CENTER FOR BIOLOGICAL DIVERSITY – EARTHJUSTICE  
GULF RESTORATION NETWORK  
NATURAL RESOURCES DEFENSE COUNCIL – SIERRA CLUB

January 23, 2017

Re: *Receipt of Revised MMPA Incidental Take Application for Oil and Gas  
Geological and Geophysical Activities in the Gulf of Mexico*

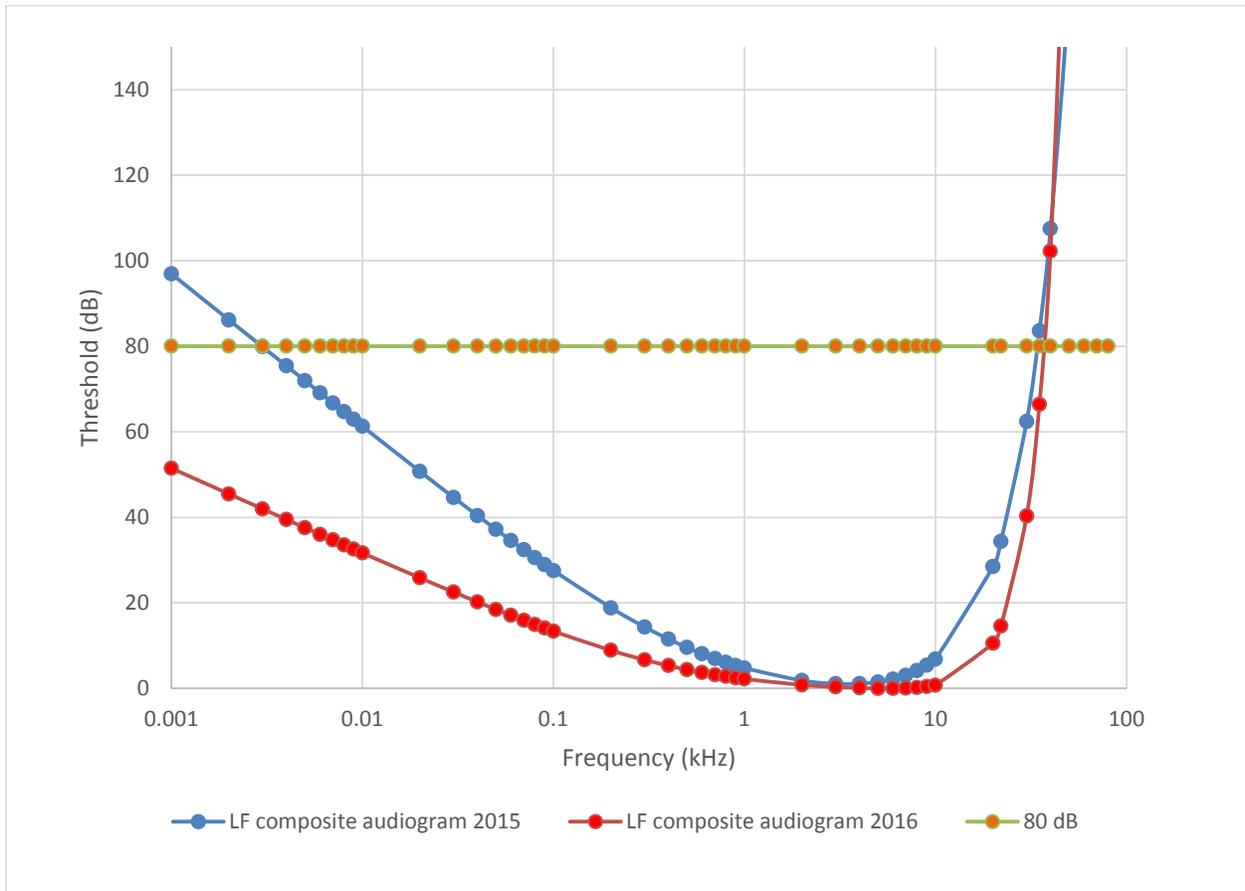
In addition, on page 7 of the 2016 proposed changes, NOAA reviews four models for frequencies of best hearing and states that these models predict “thresholds within ~40 dB of best sensitivity as low as ~30 Hz and up to 25 kHz.” However, rather than use the predictions of these models, NOAA proposes a curve that predicts LF cetaceans can hear 30 Hz at 10 dB above best hearing, not 40 dB. Under NOAA’s model, whales could even hear sound at 10 Hz with only a 25 dB decrement from best hearing—which the best available science for baleen whale hearing modeling (*e.g.*, Houser et al. 2001; Cranford and Krysl 2015) and general mammalian hearing data strongly suggests is impossible. *See infra* footnote 8.

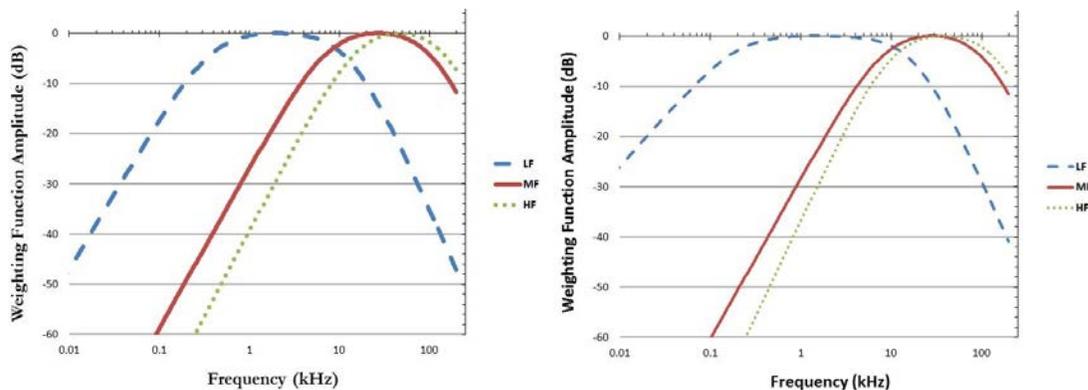
The impact of the new LF cetacean parameters is immediately obvious in our Figure 2 below, which compares Figure PC3<sup>7</sup> of the new 2016 criteria (*see right plot below*) with the curve depicted in NOAA 2015 Draft Guidance (page 12) (*see left plot below*). In contrast to the similar shapes of all the 2015 weighting functions, the new LF cetacean curve produces a biologically unrealistic, extended, and flattened curve.

NOAA’s proposed LF cetacean model also sharply deviates from data pertinent to other LF specialist mammals. For example, humans are LF hearing specialists that have a best hearing range of approximately 400 Hz to 16 kHz.<sup>8</sup> But, unlike the LF cetacean model proposed by NOAA, human hearing ability is 25 dB below best hearing at 200 Hz—not the 10 Hz value generated by NOAA’s proposed hearing curve. As another example, the kangaroo rat (another LF hearing specialist) has best hearing that starts to diminish at approximately 500 Hz. By 100 Hz, the kangaroo rat’s hearing threshold is at least 10 dB above best hearing, and at 20-30 Hz is
